King County International Airport Drainage Basin #5

Source Control Report

Addendum 1 – Responses to 1/23/09 Ecology Comments

Basin #5 PCB Data Map
Drainage Basin #5 Source Control Report

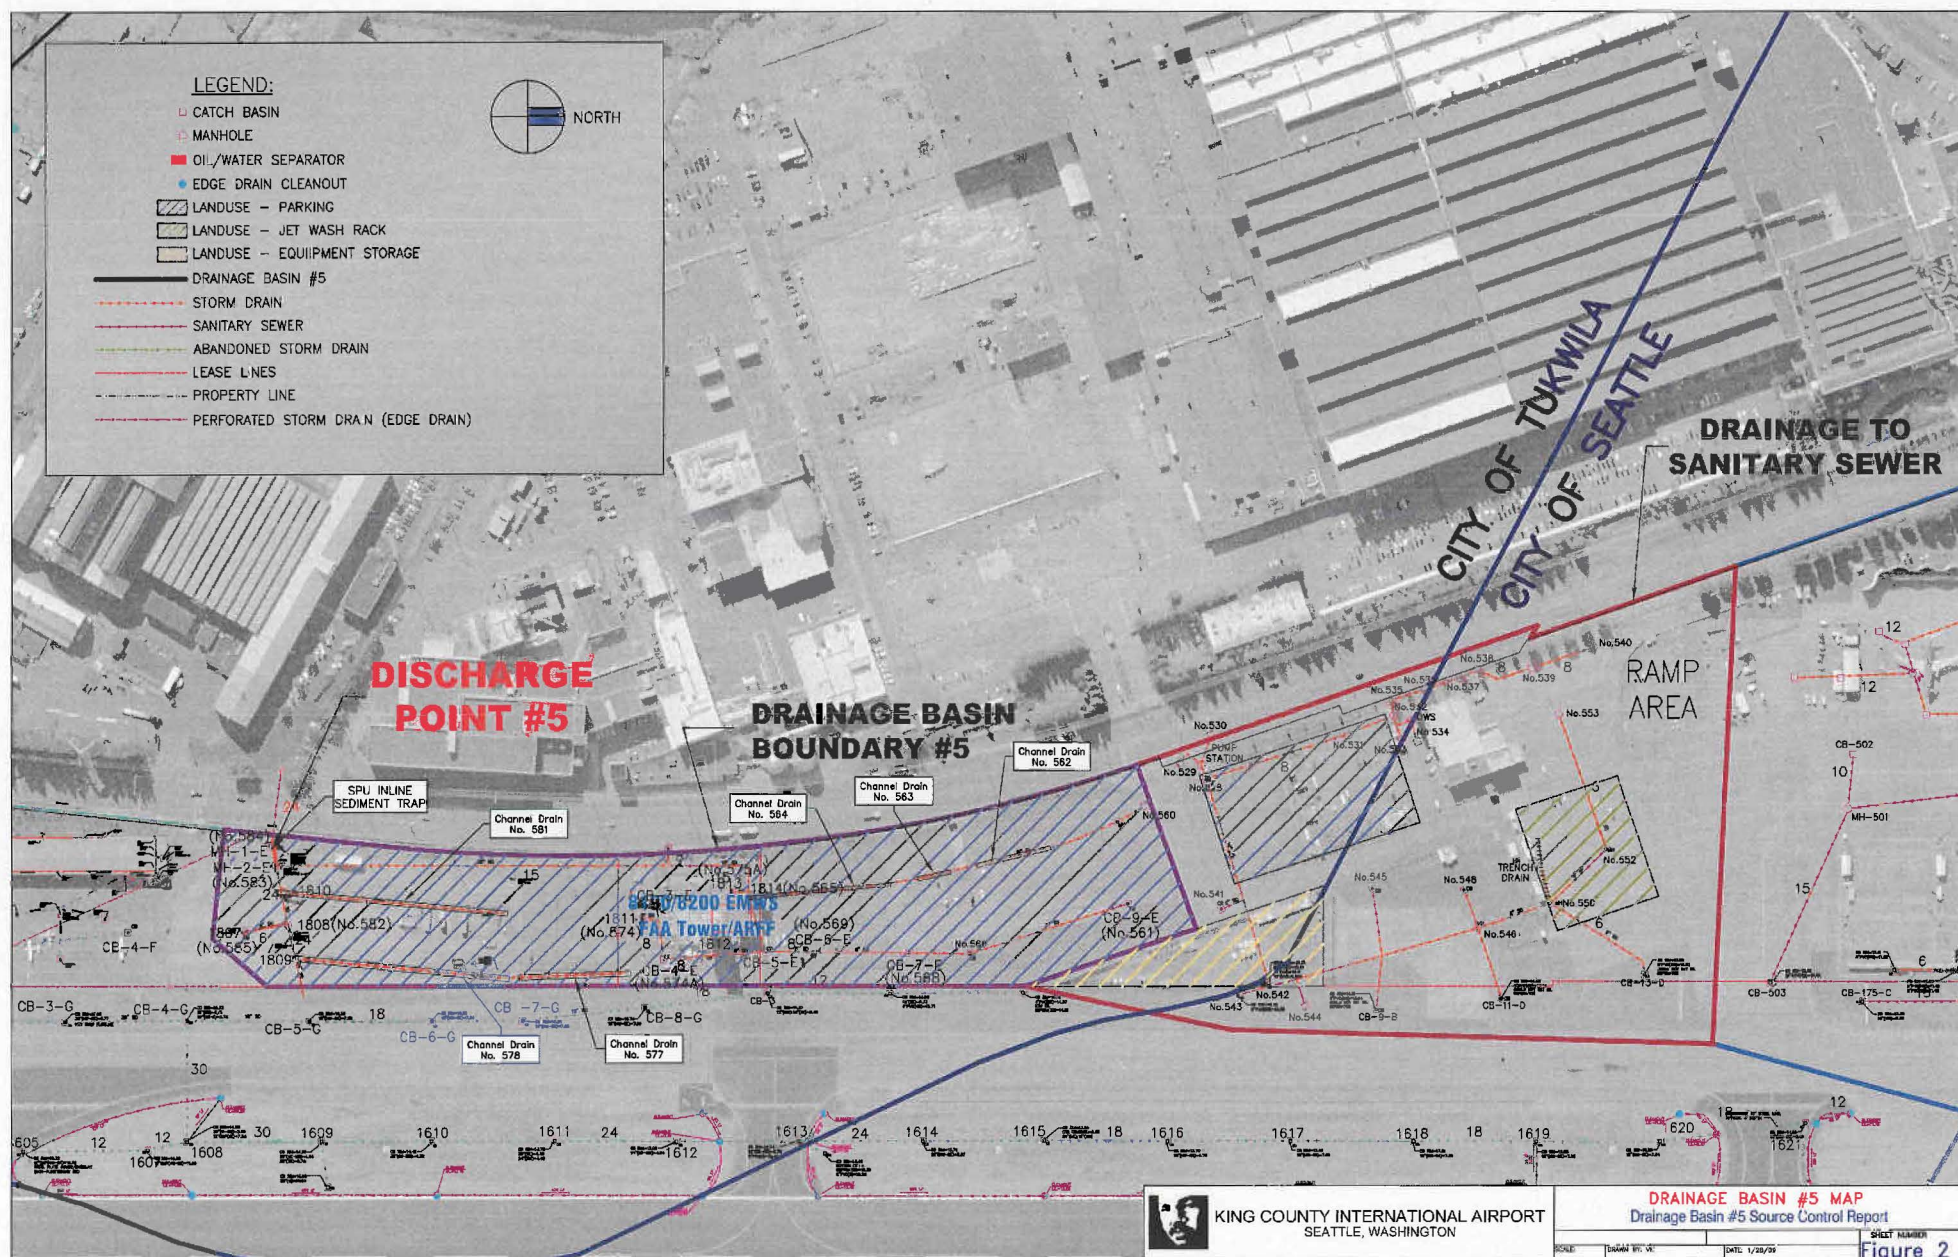
Comment	Response
<p>At the bottom of the legend the following text appears: CB, PIPE, OR MH CONFIRMED DOES NOT EXIST COULD NOT FIND, UNABLE TO CONFIRM OR DENY EXISTENCE What does this mean? The text is confusing, and there are no key symbols associated with the text.</p>	<p>This legend label was an error and will be removed from Figure 1 and 2. The revised figures are provided in Attachment 1.</p>
<p>Trench drains and channel drains referenced in the text and on Figure 3 are not shown on Figure 2 to be part of the stormwater system/MS4. The purpose of these drains is to collect and convey stormwater runoff; as MS4 features, they must be fully included in the mapping and discussion of Basin 5 (particularly Chapter 5).</p>	<p>Figure 2 was revised to show drainage from the channel drains to the stormwater system. Lines depicting the stormwater lines have been drawn within the channel drains to show their connection to the stormwater system. The revised figure is provided in Attachment 1.</p>
